Addendum: 2

Date: 08/21/2026

Project: Northwest Allen County Schools
Huntertown Elementary School Mechanical Upgrades

Comm #: 26842

E202

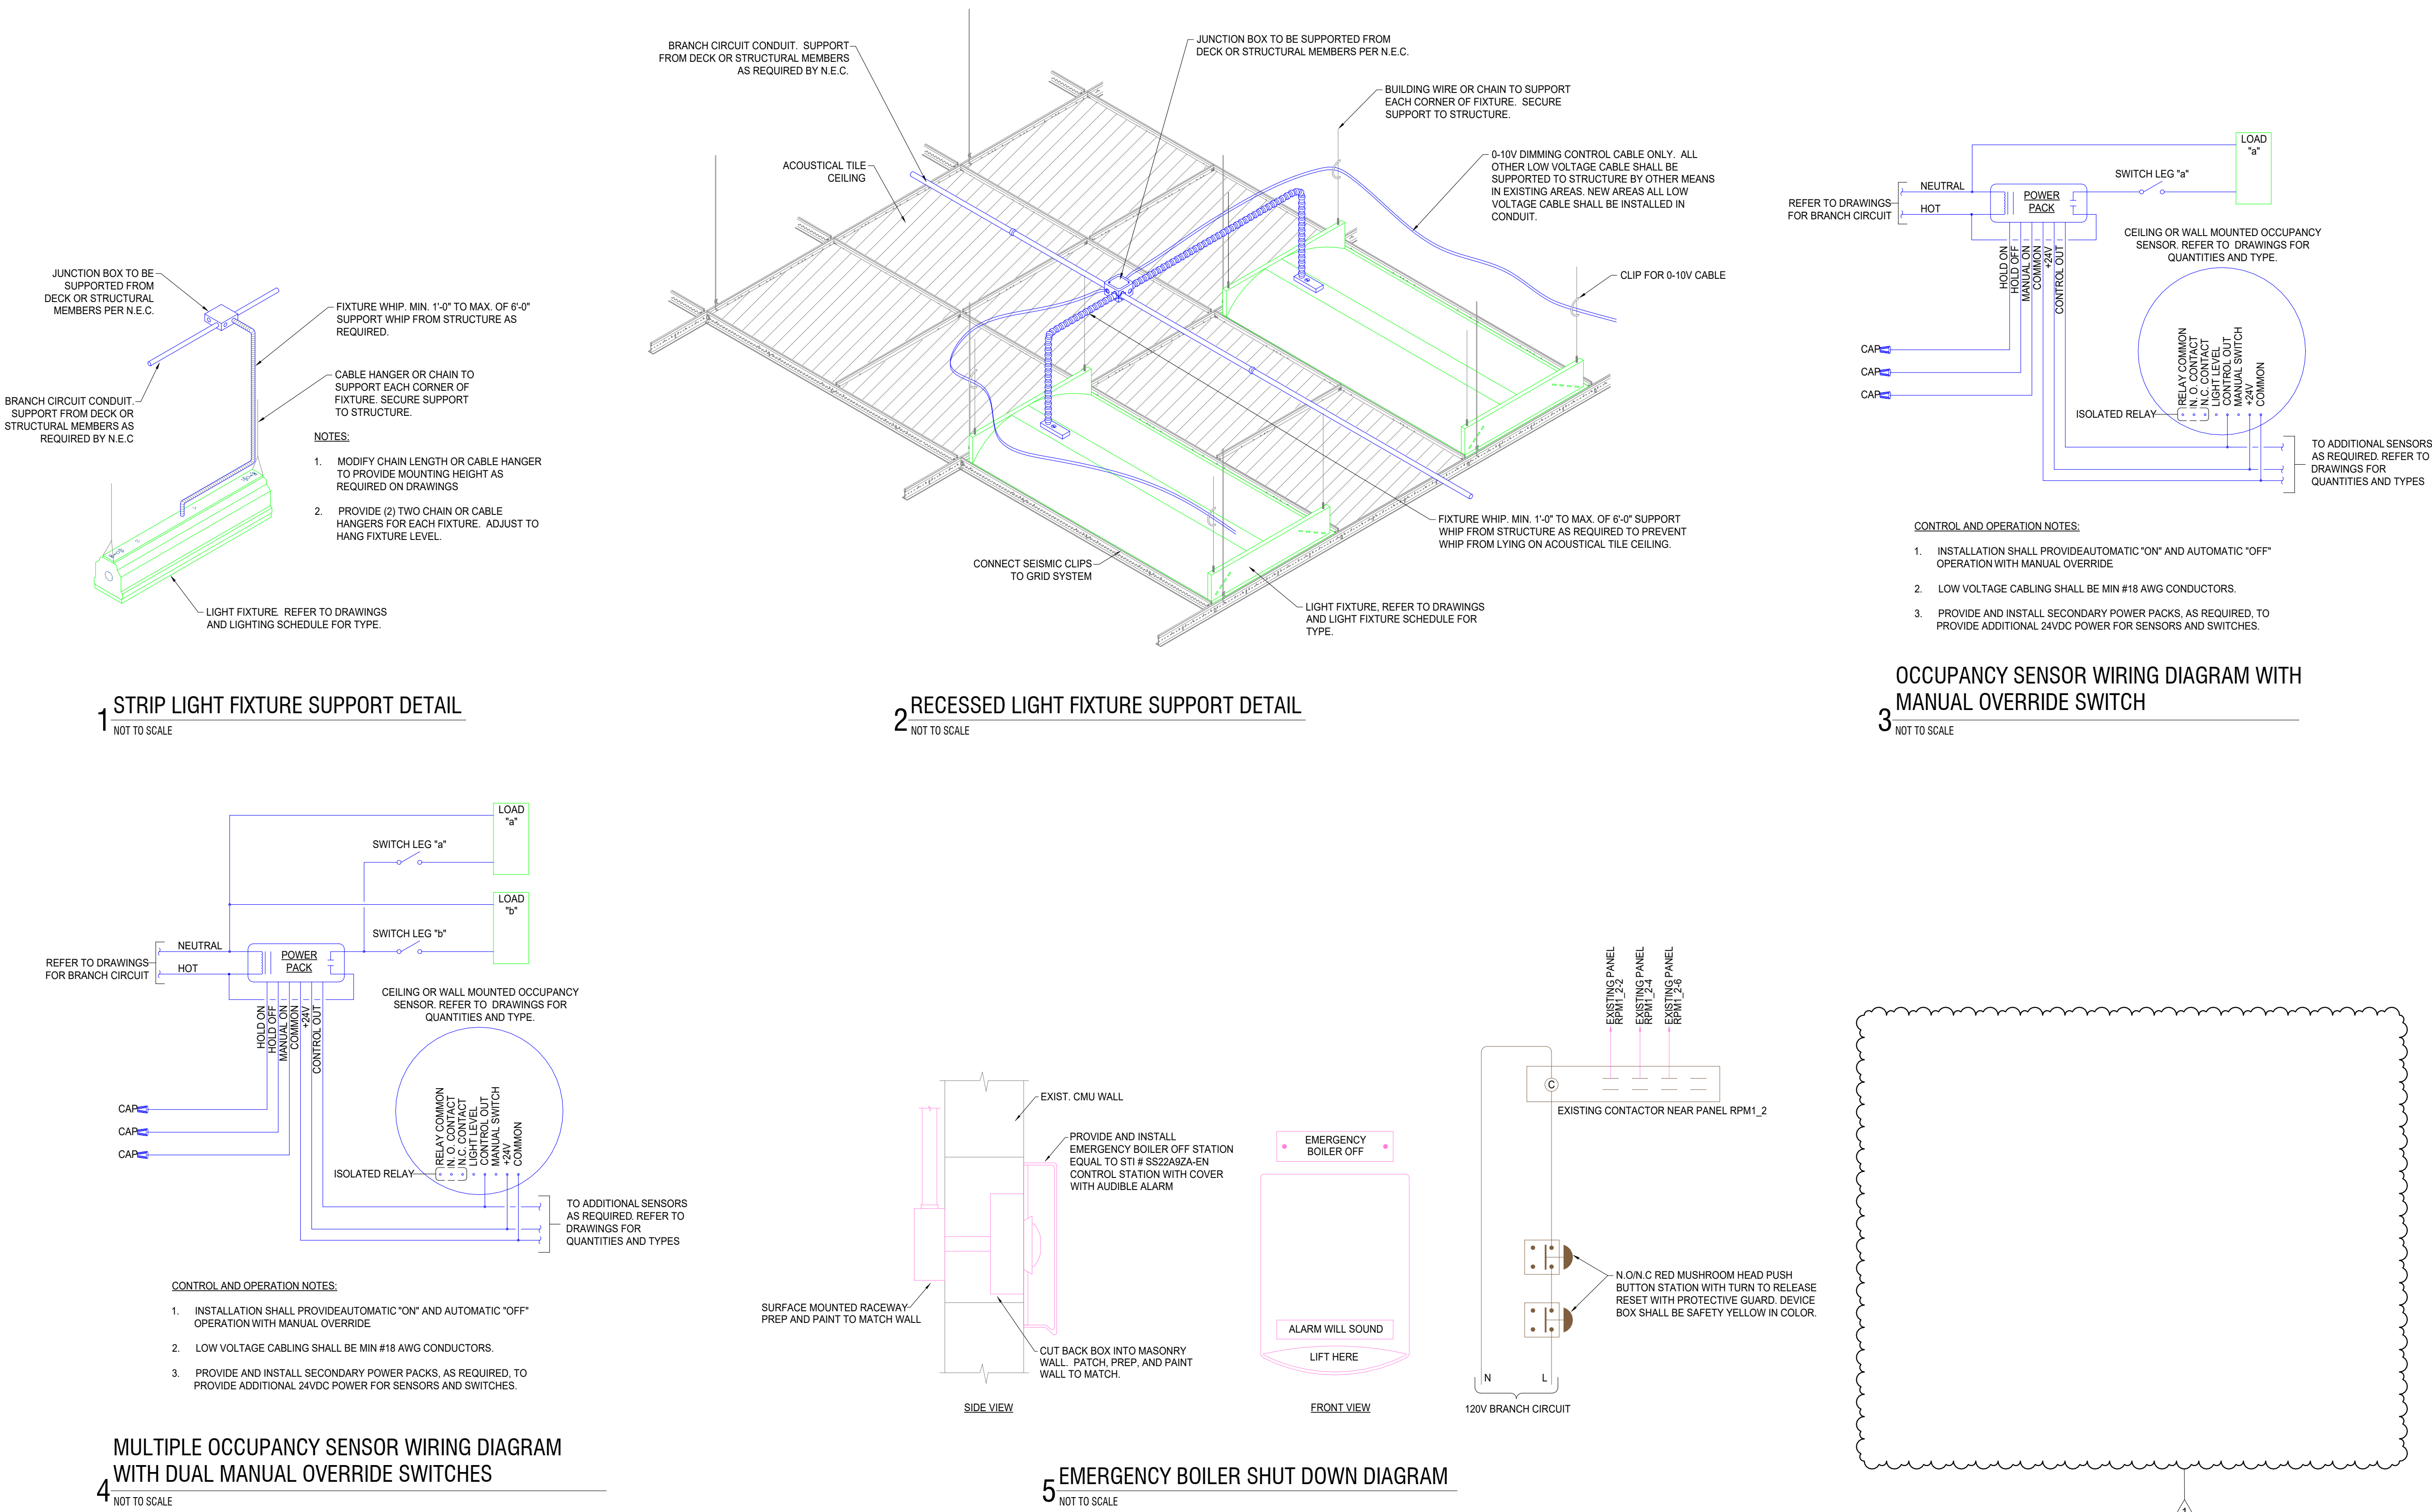
- A. Revised plans note #9. Existing Fire alarm control panel is Notifier NFW2-100
- B. Thermostat rough-in locations shown.
- C. Disconnect switches to be installed shown on FCUs. Refer to equipment schedule for additional information.
- D. Revised plan note #8 and Utility transformer and pad scope. Electrical scope of work associated to be under separate contract shown for reference only.

- PROVIDE AND INSTALL CONCRETE PAD FOR UTILITY TRANSFORMER PER UTILITY COMPANY SPECIFICATIONS. EXTEND (2) 4" ELBOW FROM PRIMARY WINDOW IN PAD TO INTERCEPT EXISTING PRIMARY CONDUIT AND CONDUCTORS. CUT, TRENCH, BACKFILL AND PATCH ASPHALT AND CONCRETE AS REQUIRED FOR INTERCEPTION OF PRIMARY. INTERCEPT AND EXTEND EXISTING SECONDARY CONDUIT AND CONDUCTORS AND REROUTE TO NEW SECONDARY WINDOW LOCATION. COORDINATE WITH UTILITY AS REQUIRED.

- ELECTRICAL SCOPE ASSOCIATED WITH BOILER ROOM, CHILLER AND UTILITY TRANSFORMER TO BE COMPLETED UNDER SEPARATE CONTRACT. REFER TO ENLARGED BOILER ROOM POWER AND SYSTEMS PLAN FOR ADDITIONAL INFORMATION.

SHEET:
E602

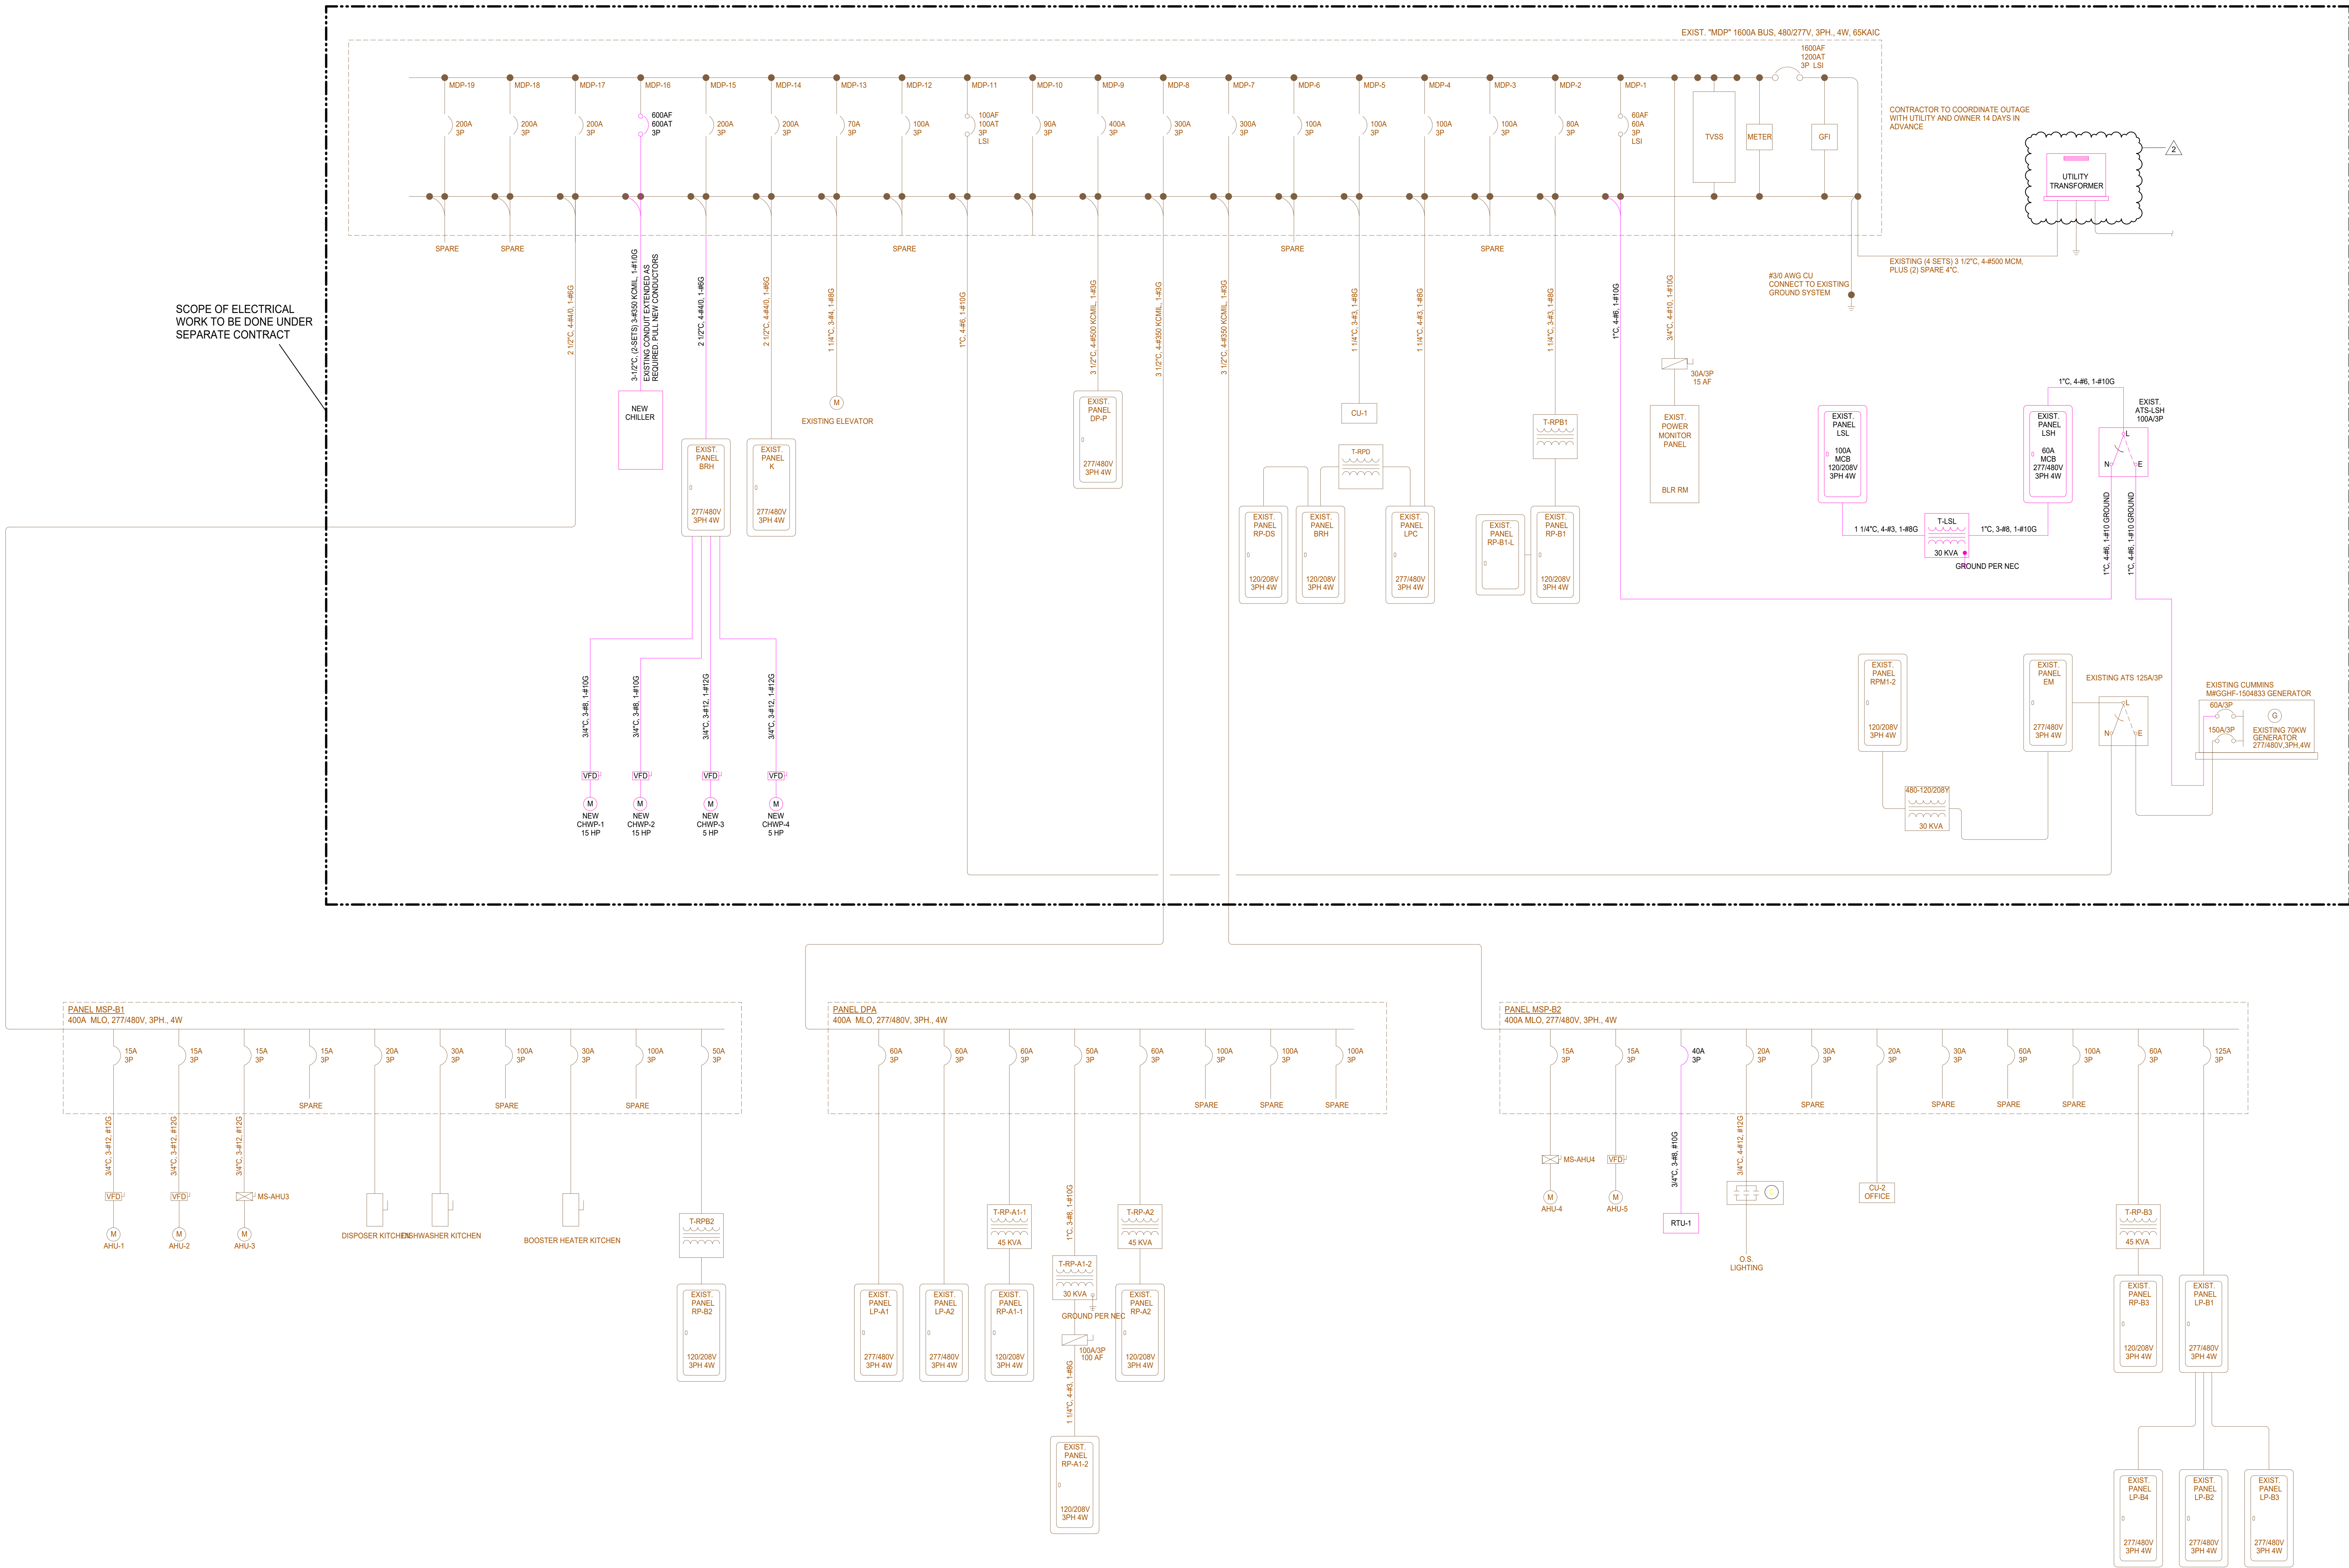
- A.** Revised utility transformer to indicate new installation. Electrical scope of work associated to be under separate contract shown for reference only.
